- **Memo** -

Date: **August 30,2020**

The following notes are the result of a call to Carl Childs PE about his report on his report regarding the Richmond Water Tank and my further investigations on the Water Tank.

**Reference:** Town of Richmond Water Storage tank

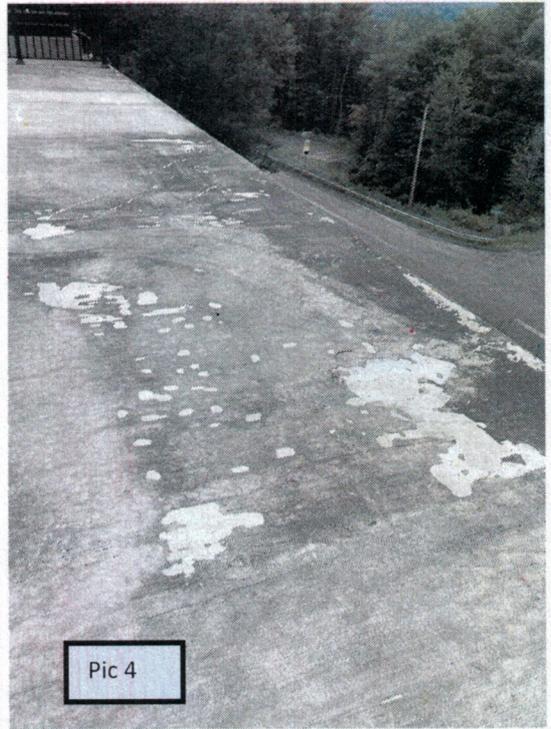
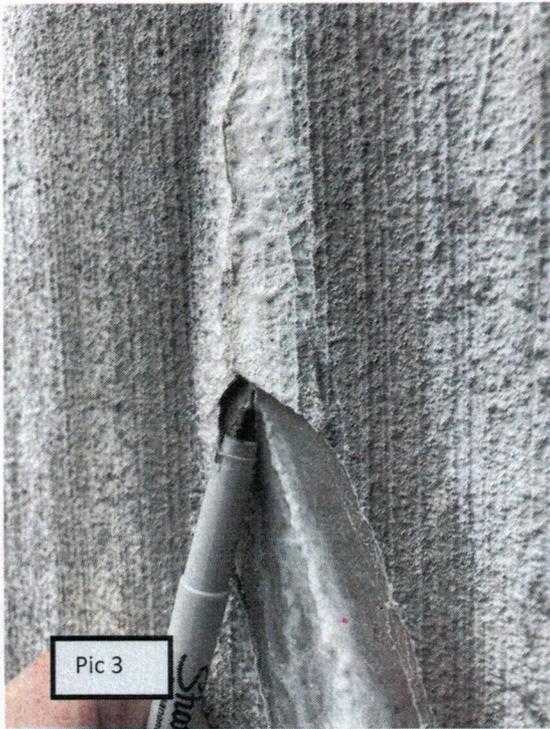
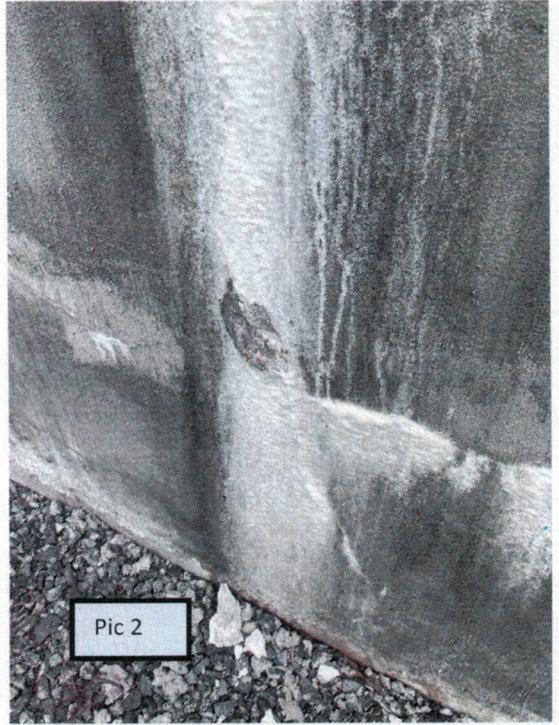
2. After the call, I made a site visit to the water tank and took the some pictures. My observations are as follows:
  - a. Pic 1 and 3 show active leaks. Pic 3 shows that the coating is flaking off the concrete and is ¼” elevated from surface of the concrete.

Pic 6

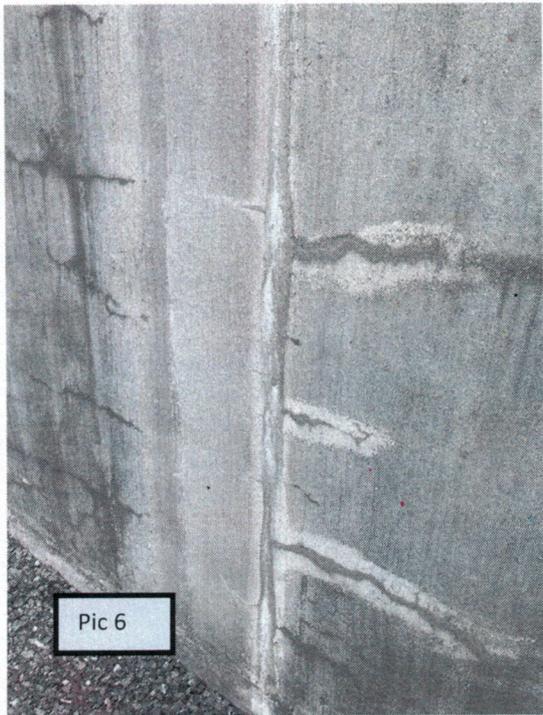
- b. Pic 6.. As far as I could tell, this seems as a patch that was made. Not sure when patch was made, guessing when tank was just accepted.
  - c. The Cementous coating of the tank is coming off, especially on the roof. See pic 4 and 9.

Pic 7

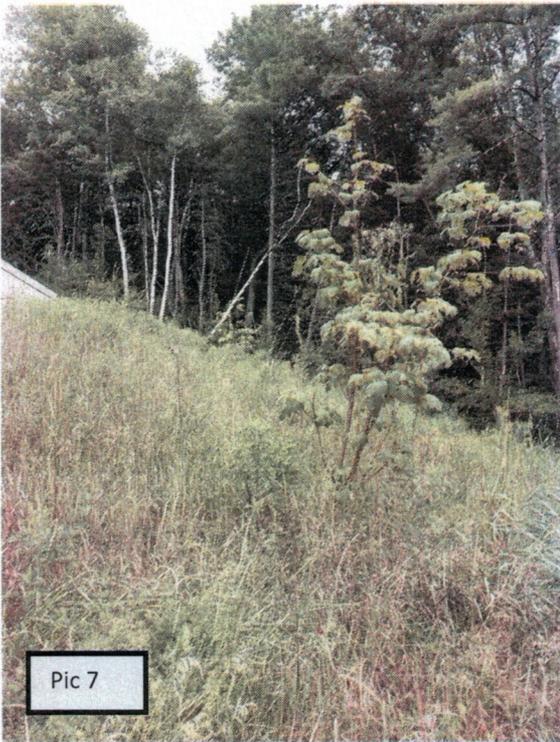
- d. The steep slope has long grass and a few shrubs starting to grow. Refer to pic 7
3. After the above, I made a few calls to structural engineers in order to determine what other structural engineers would say about the use of epoxy rebar and the Richmond Water Tank:

shrubs and trees on the back slope of dams was noted as lack of maintenance. Tall grass and a couple of shrubs on the steep embankments were noted.

Pic 9

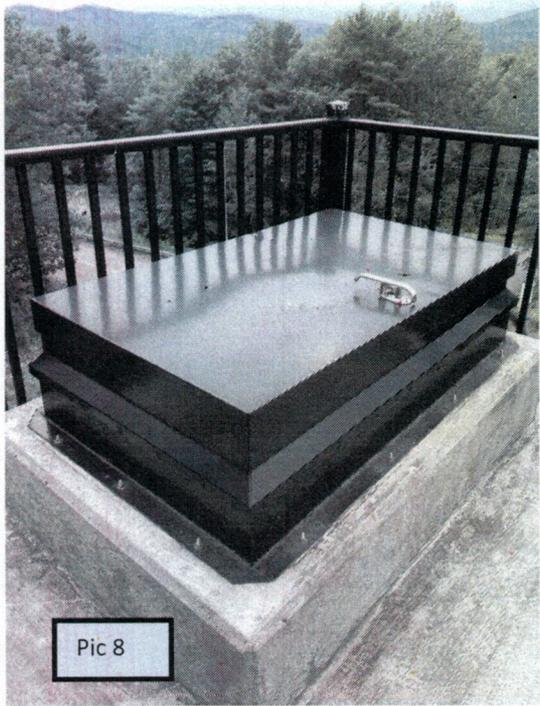
- The writer is not a fan of Cementous coatings applied to a concrete structure to make it more aesthetically pleasing. The writer noted that the coating is flaking off the main structure especially on the roof. The writer is surprised to find the coating flaking off after less than 5 years after installation.
- The writer is not sure if epoxy or coated reinforcing should have been used. Granted the cost of the tank construction would have been more, but it is the writers thinking that the tank would last longer. Noting signs of rust colored spots in two locations, the writer is concerned that the chlorinated water will deteriorate the rebar and cause the concrete to spall.
